AIR - INCORPORATION OF ACC VALVE BRACKETS AND STATOR ROD FEATURING CHROME PLATED
BEARING DETAILS - CATEGORY CODE 4 - MOD.ENG-75-0006

(1) AIRCRAFT: Airbus A320

(2) ENGINE: V2500-A1 Engines, Serial No.V0014 through V0085

V2500-ENG-75-0006

Replacement of the stator rod
Fig.1

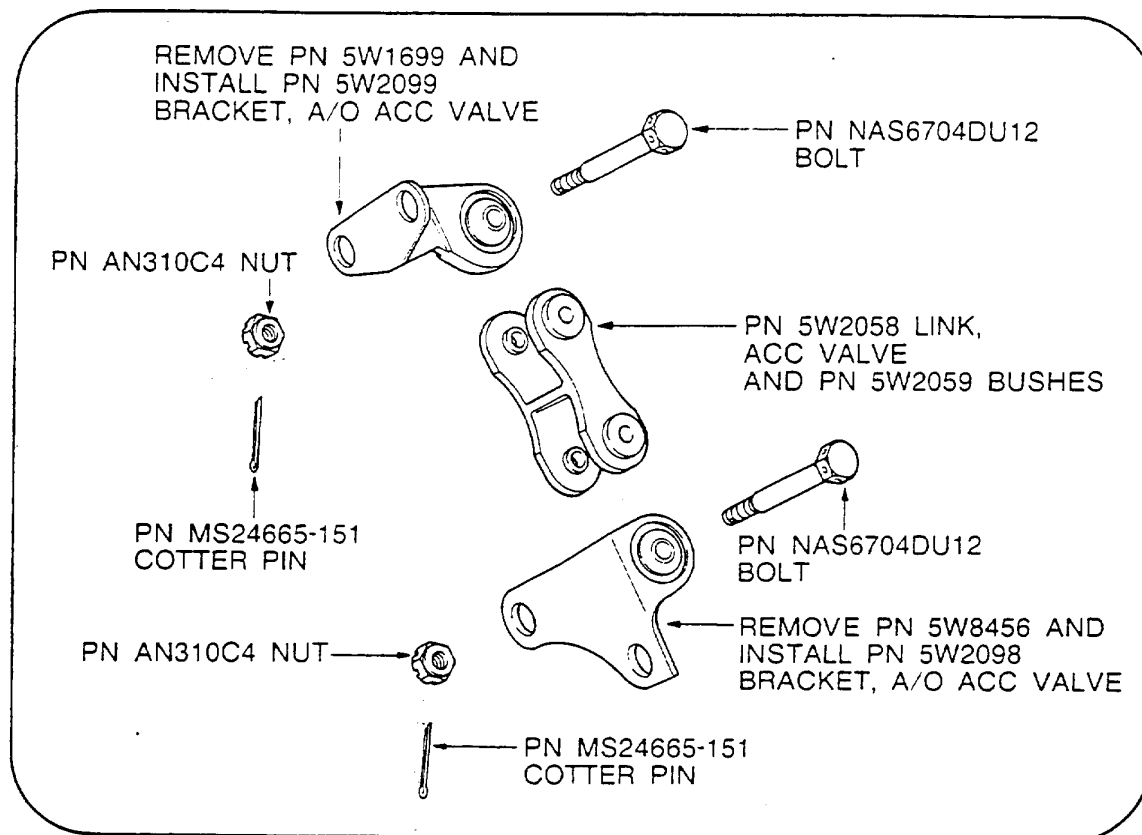
- (a) P/N 5W2098 ACC valve bracket assembly supersedes old P/N 5W8456 ACC valve bracket assembly.
- (b) P/N 5W2099 ACC valve bracket assembly supersedes old P/N 5W1699 ACC valve bracket assembly.
- (c) P/N 5W2096 stator rod assembly supersedes old P/N 5W8232 stator rod assembly.

- (1) Remove PN MS24665-151 Cotter pin from the bolt retaining PN 5W8232 stator rod to the ACC actuator and discard it.
- (2) Remove PN AN310C4 nut and PN NAS6704DU20 or PN 5W2093 bolt.
- (3) Remove PN MS24665-151 cotter pin from the crank retaining another end of the stator rod to the rod bracket and discard it.
- (4) Remove PN AN310C4 nut.
- (5) Remove two PN 4W0003 nuts and PN 4W0649 bolts which retain the rod bracket to the K flange.
- (6) Remove the rod bracket with crank from the ACC valve to remove PN 5W8232 stator rod.
- (7) Be in position PN 5W2096 stator rod and align holes of the rod end bearings, the ACC valve and ACC actuator.
- (8) Install PN NA6704DU20 or PN 5W2093 bolt and PN AN310C4 nut to the ACC actuator.
- (9) Install the rod bracket with crank to the K flange with two PN 4W0649 bolts and PN 4W0003 nuts.

- (10) Torque the PN 4W0003 nuts to 10 to 170 lbfin. (16,95 to 19,21 Nm).

- (11) Torque two PN AN310C4 nuts to 32.5 to 42.5 lbfin. (3,67 to 4,80 Nm) and align the slot of the nut and pin hole of the bolt or crank.
- (12) Safety the nuts with new PN MS24665-151 cotter pins.
- (13) Remove two PN 4W0003 nuts and PN 4W0471 bolt to release PN 5W1699 ACC valve bracket from the M flange.

Replacement of the ACC brackets
Fig.2

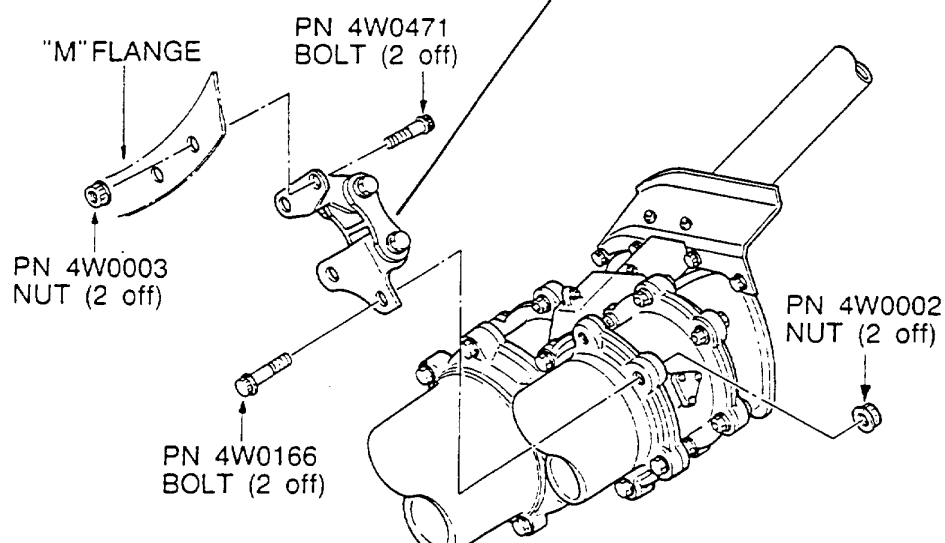
- (14) Remove two PN 4W0002 nuts and PN 4W0166 bolts to remove assembly of PN 5W2058 ACC valve link and PN 5W1699 ACC valve bracket.
- (15) Remove PN MS24665-151 cotter pins from the assembly of ACC valve brackets and ACC valve link and discard them.
- (16) Remove two PN AN310C4 and PN NAS6704DU12 bolts to disassemble the assembly of ACC valve brackets and ACC valve link.
- (17) Assemble PN 5W2098 ACC valve bracket, PN 5W2058 ACC valve link and PN 5W2099 ACC valve bracket with two PN AN310C4 and PN NAS6704DU12 bolt.

- (18) Torque two PN AN310C4 nuts to 32.5 to 42.5 lbfin (3,67 to 4,80 Nm) and align the slot of the nut and pin hole of the bolt.
- (19) Safety the nuts with new PN MS24665-151 cotter pins.
- (20) Install PN 5W2098 ACC valve bracket to the ACC valve with two PN 4W0166 Bolts and PN 4W0002 nuts.
- (21) Torque the nuts to 85 to 95 lbfin (9,6 to 10,73 Nm).
- (22) Install the PN 5W2099 ACC valve bracket to the M flange with two PN 4W0471 bolts and PN 4W0003 nuts.
- (23) Torque the nuts to 150 to 170 lbfin (16,95 to 19,21 Nm).
- (24) Examine all the connecting points of the ACC system for any damage.
